STRIPE 1402

SUPERSTRUCTURE STEEL FRAMING PLAN

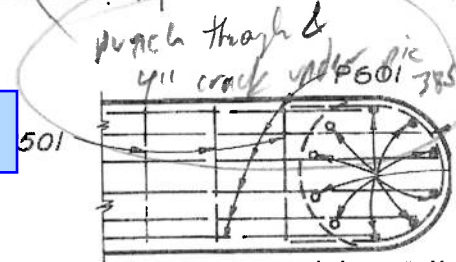
Replace cross frames

West Beam Limits of Heat Straightening:
14' from face of Pier 1 (South Pier) to 28'
from face of Pier 1 (South Pier)

replace crossframes

East Beam Limits of Heat Straightening:
10' from face of Pier 1 (South Pier) to 28'
from face of Pier 1 (South Pier)

WC1 Repair: Punch through & 4" crack
Picture 385

Correct Location of repairs

Location depicted incorrectly.
